JUMPER CARTER SEASE/ARCHITECTS, P.A.
412 MEETING STREET, WEST COLUMBIA, SOUTH CAROLINA 29169
(803) 791-1020 (803) 791-1022 FAX

UNIVERSITY OF SOUTH CAROLINA CAPSTONE CAMPUS ROOM UPGRADES

PROJECT NO: 11103

ADDENDUM 02

3
1-7
CEILING DETAIL
SCALE: 1 1/2" = 1'-0"
SEE 2/1-1 FOR TYP. NOTES

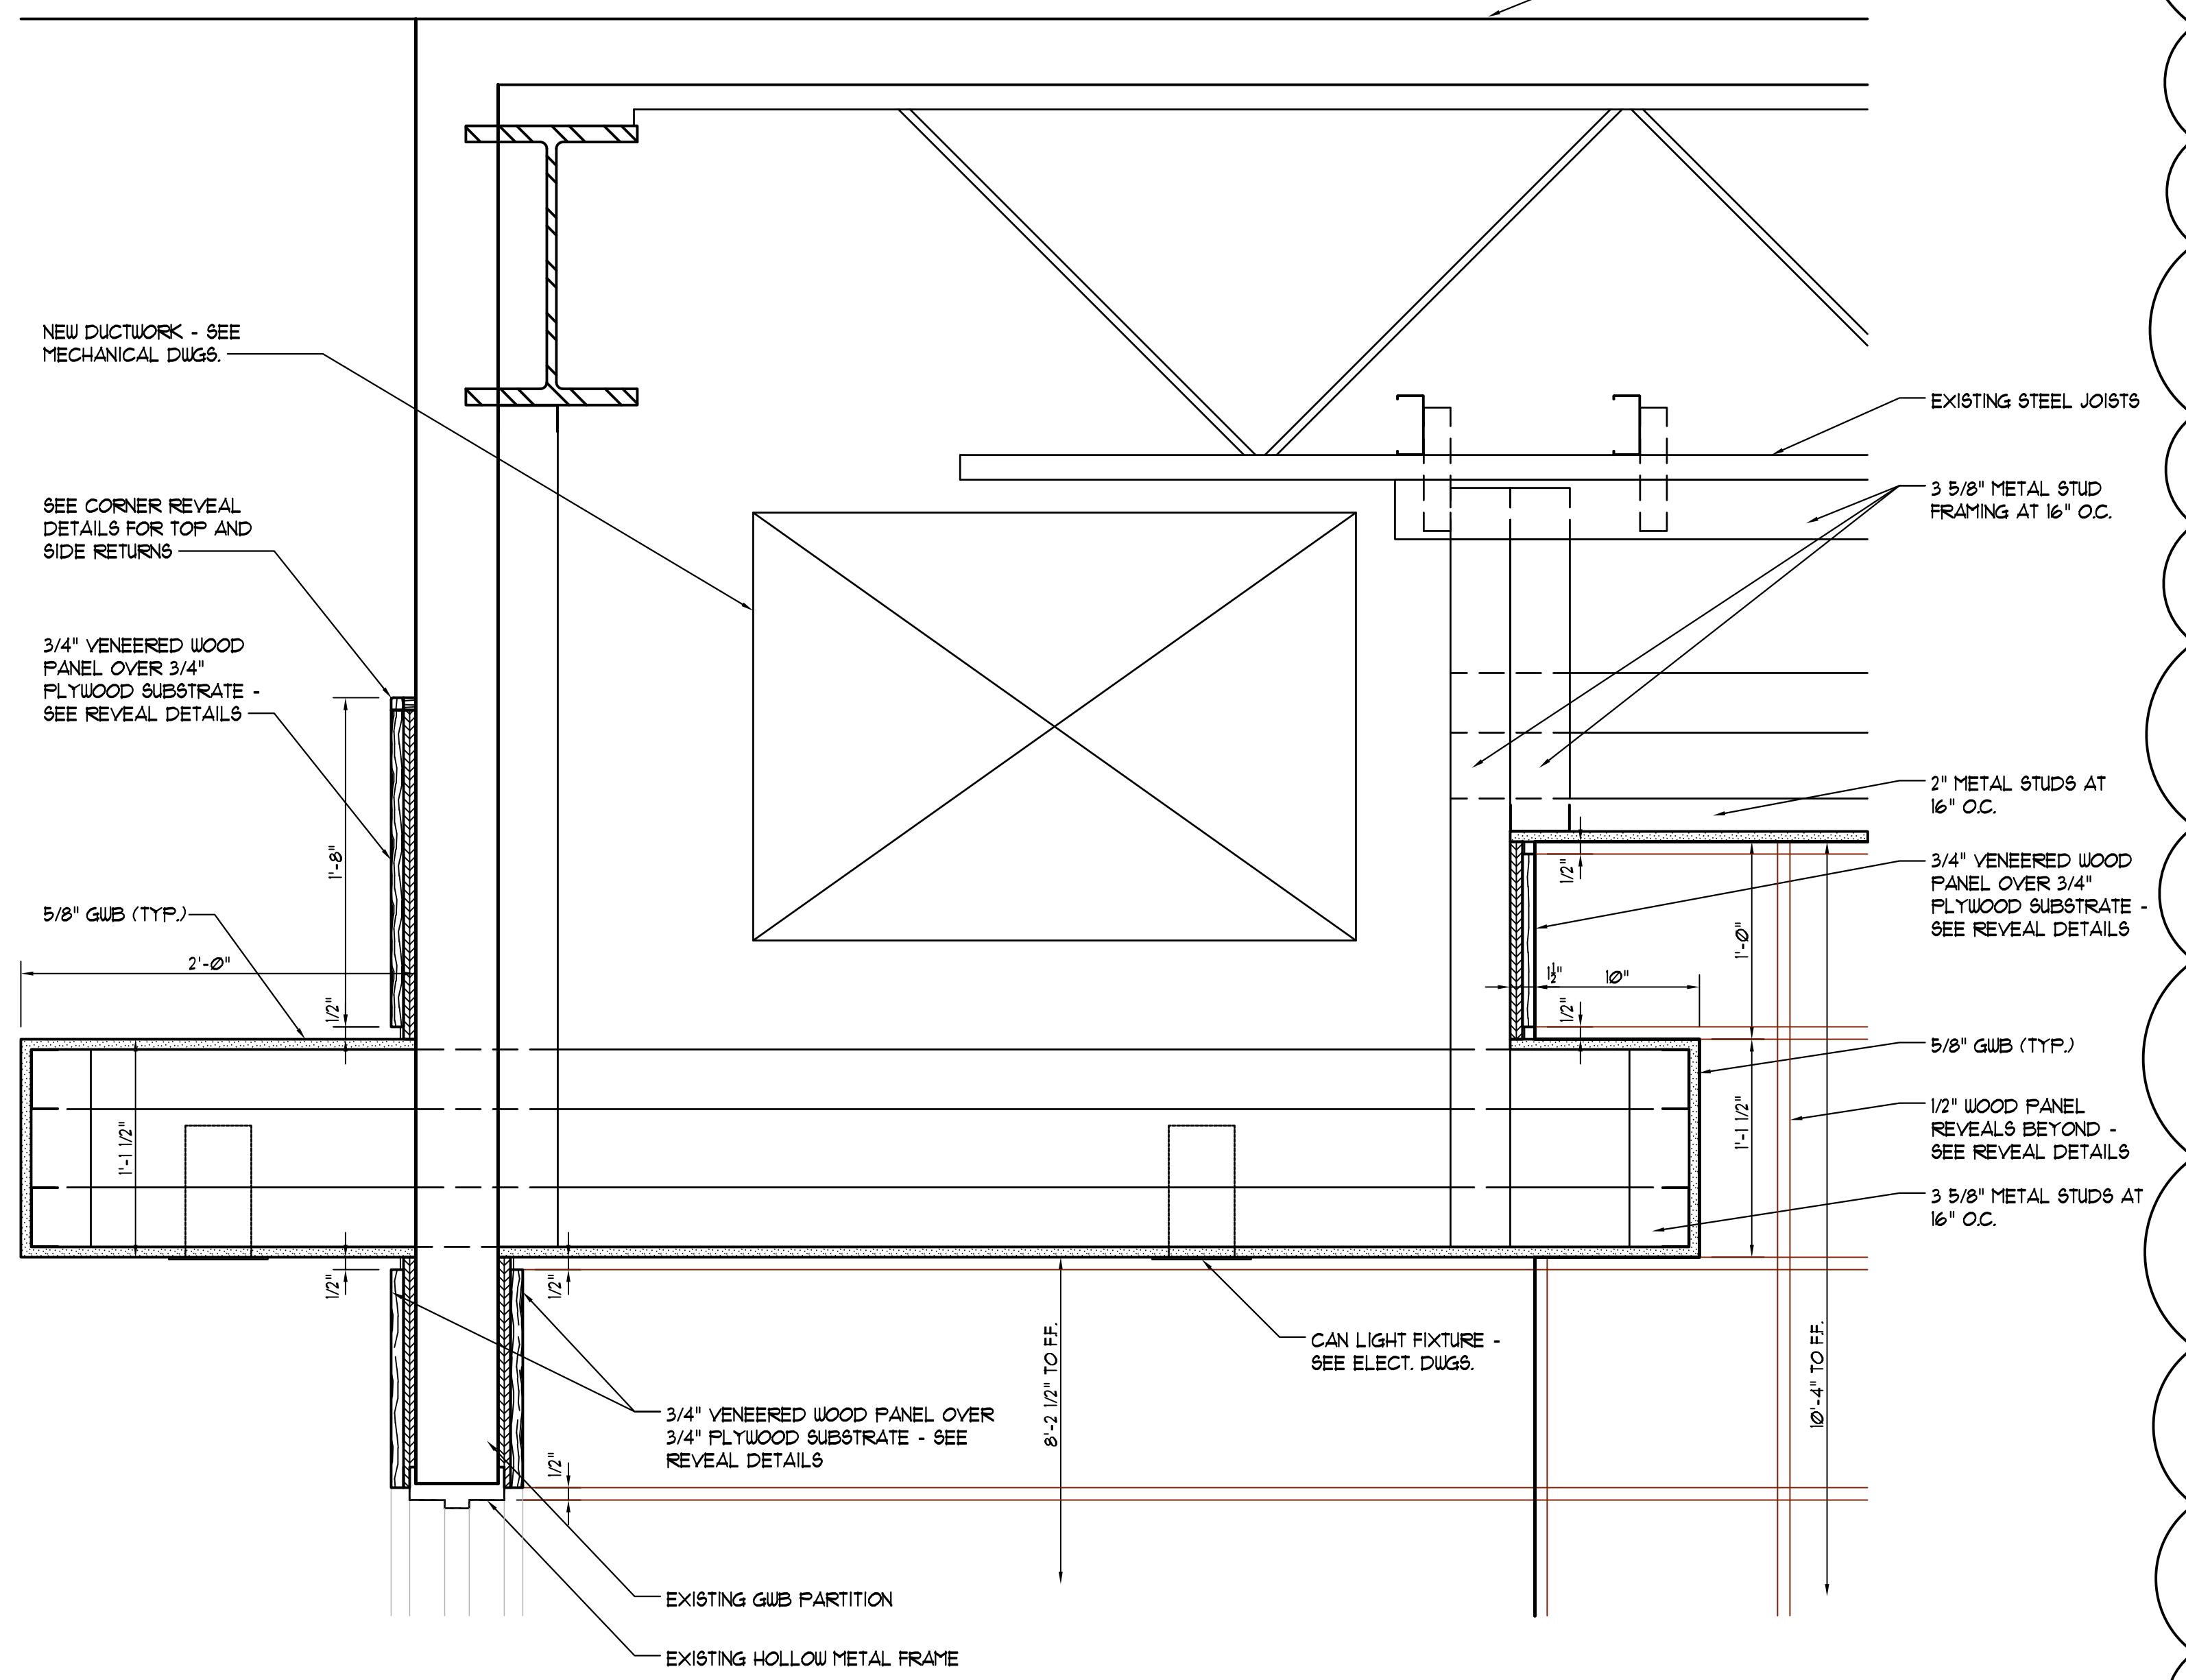
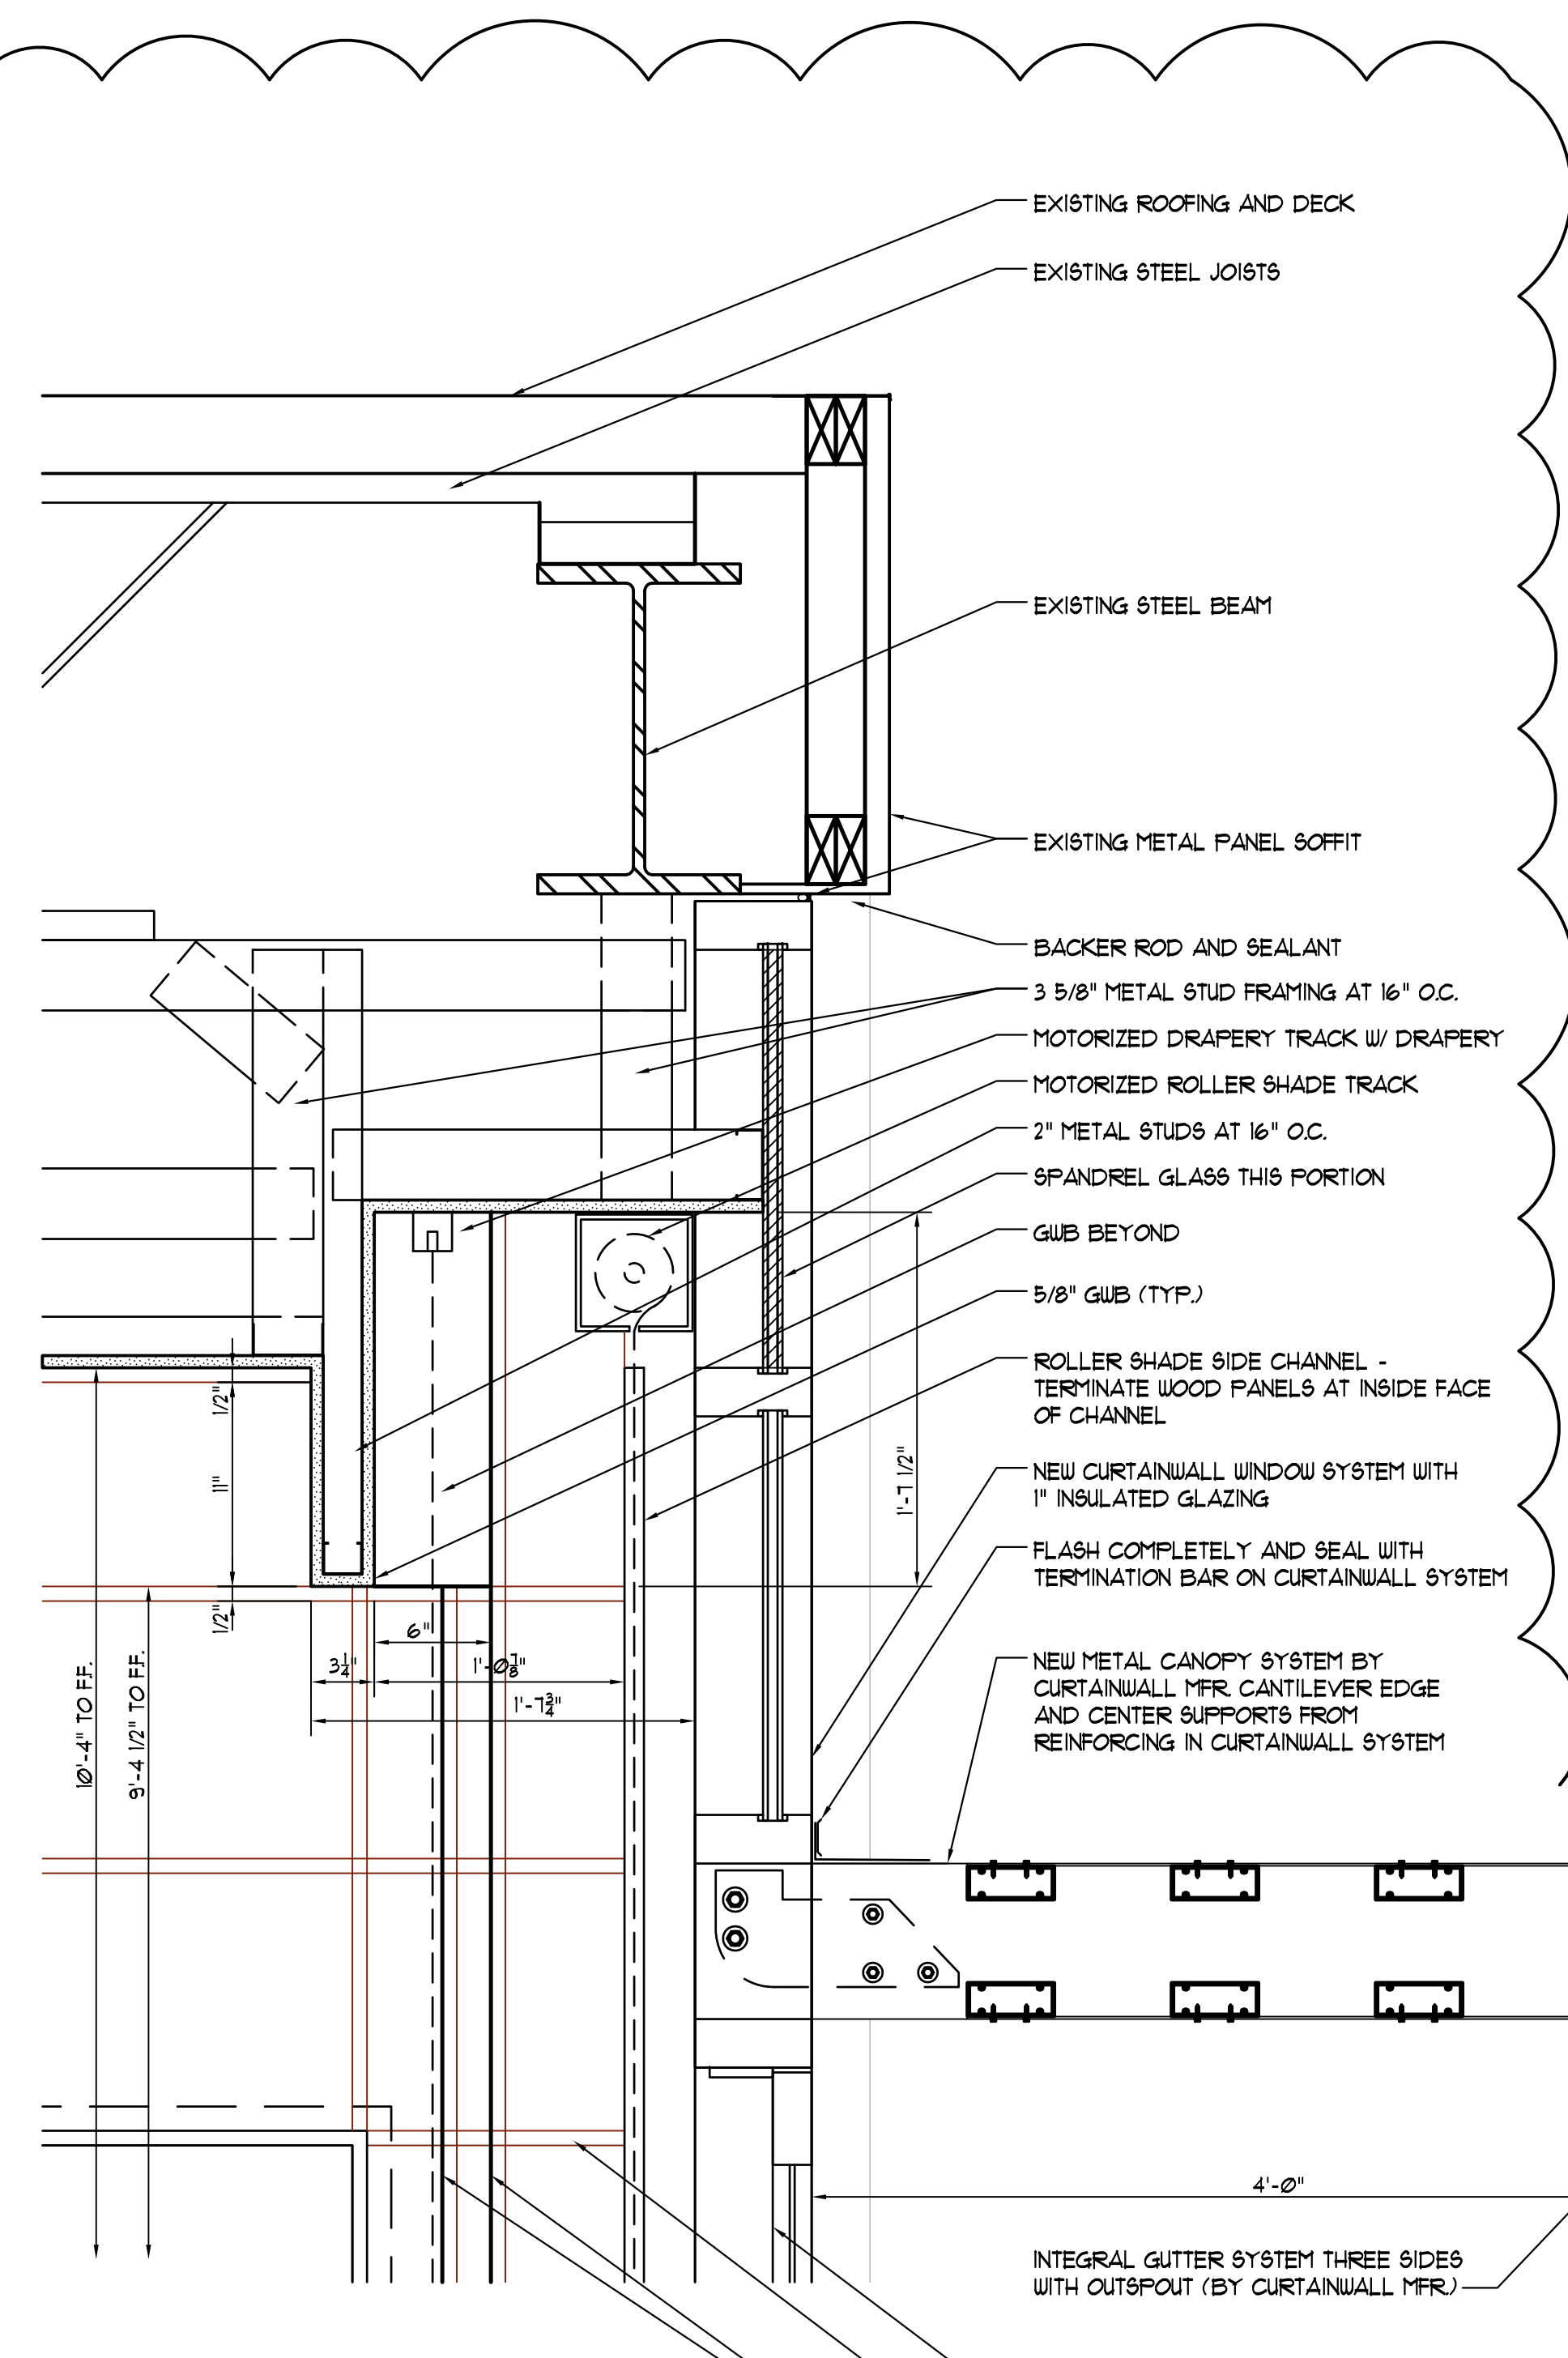
- 1. Drawing I-7 CEILING DETAILS: OMIT** Drawing I-7 and **REPLACE** it with NEW DRAWING I-7.
- 2. Drawing I-5 DOOR & FINISH SCHEDULES / COLOR SCHEDULE / DOOR & WINDOW TYPES & DETAILS / PANEL DETAILS; CHANGE** Wood Veneer Panel Reveal Details as shown.
